APPLICATION NO.	FILING DATE	FIRST NAMED INVENTOR	ATTORNEY DOCKET NO.	CONFIRMATION NO.
10/696,984	10/30/2003	James D. Dale	1062/D74	7856
2101	7590	02/21/2006	EXAMINER	
BROMBERG & SUNSTEIN LLP 125 SUMMER STREET BOSTON, MA 02110-1618			LUGO, CARLOS	
			ART UNIT	PAPER NUMBER
			3676

Office Action Summary	Application No.	Applicant(s)	
	10/696,984	DALE, JAMES D.	
	Examiner	Art Unit	
	Carlos Lugo	3676

DETAILED ACTION

Assembly 13

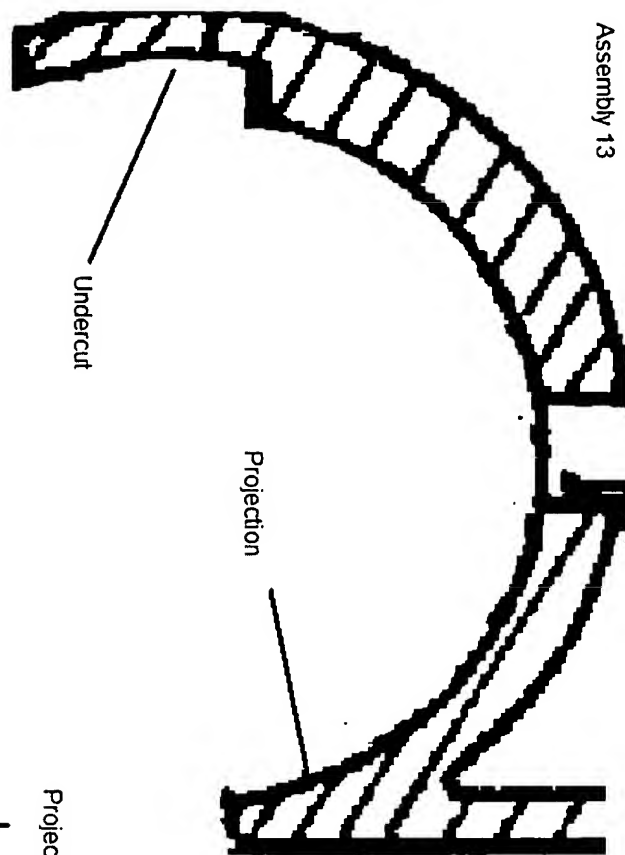
The applicant argues that Mena fails to disclose an assembly including a latching structure having a first undercut feature; a door including a latch member having a second undercut feature capable of being engaged by the first undercut feature; the second undercut feature is required to move beyond the first undercut feature in order to open and close the door; and a movable member to produce a force to prevent movement of the second undercut feature beyond the first undercut feature to lock the door in a closed position (Page 13 Line 9). The arguments are not persuasive.

As seen in attachments #1 and #2, Mena illustrates an assembly 13 wherein includes a latching structure includes an "undercut feature" that engages another "undercut feature" at the door. A moveable member (16) will expands so that the undercut features fully engage so as to latch the door. Therefore, Mena discloses every limitation presented in the claims. The rejection is maintained.
